## Independent Assessment

REV23/0008 [DA/22/0214\_Northern Lot] – DA2

184 Lord Sheffield Circuit, Penrith

Prepared by Gyde Consulting  
on behalf of Penrith City Council

Figure 2. Proposed CI 'recreation area' under DA22/0214 / REV23/0008 (Source: Draft VPA Letter of Offer, dated 28 March 2024).

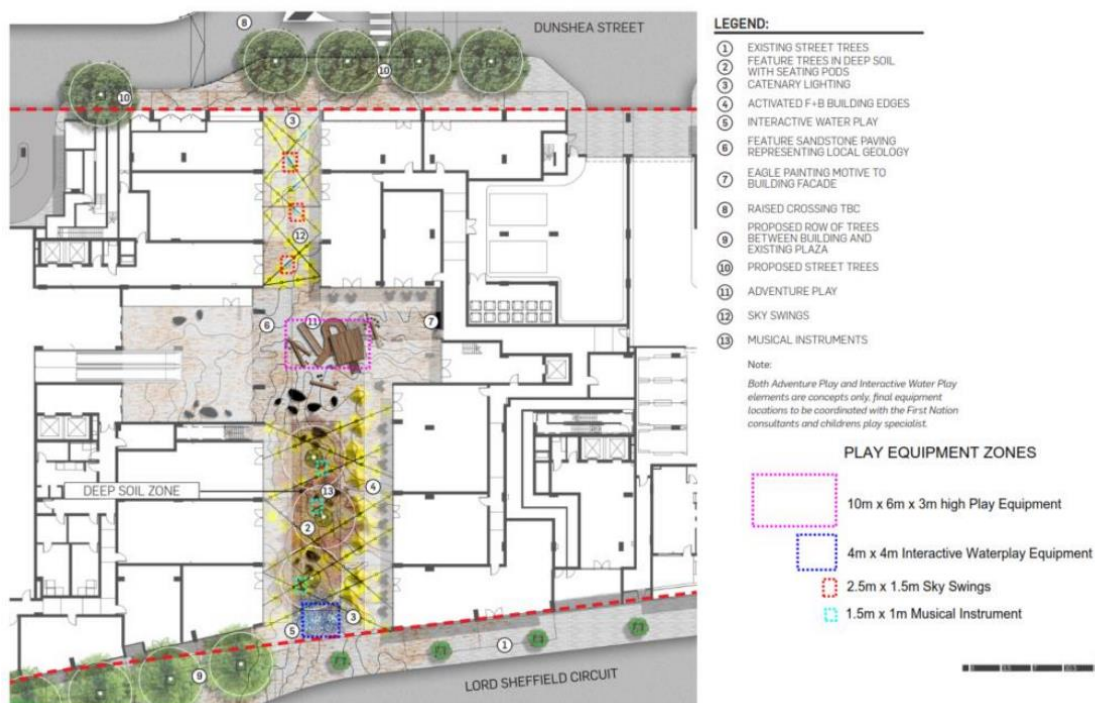
- *It is unlikely to meet the spatial requirements under the Penrith Sport & Recreation Strategy of 0.3ha-0.5ha.*
- *The plans submitted with the DA do not indicate a children's playground, rather the landscape strategy focuses on the pedestrian throughfare role of the space."*

- *The proponent has not provided sufficiently detailed plans for Council (i.e. dimensioned) to clearly establish the functionality of the space and the suitability of play equipment within the space. The panel are concerned that the function of the space, primarily as a site through link, conflicts with the proposed play equipment and safe use of the space.*

- The additional information provided by the applicant includes dimensioned plans to outline the size, type and location of the recreation children's playground equipment. This additional information demonstrates the proposed functionality of the space, suitability of the selection and size of equipment proposed within the space and contribution to the Penrith city centre.

- The plans indicate that the dimensions of the through site link and location and size of the play equipment should not result in issues regarding the safe access, use of the space or result in pedestrian conflicts.

**Figure 5. Proposed Base Case envelope (Station Plaza highlighted in green and site subject to DA1 is highlighted in red)**  
(Source: Crone Architects, December 2024)

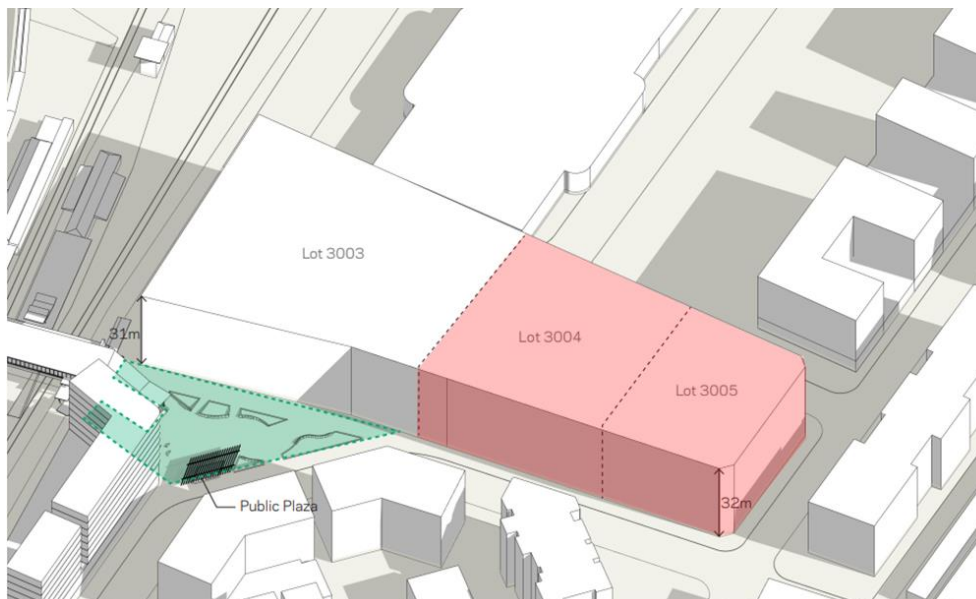
Gyde throughout our Section 8.2 review had previously questioned the calculation and interpretation of the proposed base case and requested additional legal advice from the Applicant. Specifically, Gyde questioned whether it is appropriate to apply solid massing (block form) across the entire site to the site boundary to represent the base case and whether the base case envelope should also consider the expected controls under the relative EPIs.
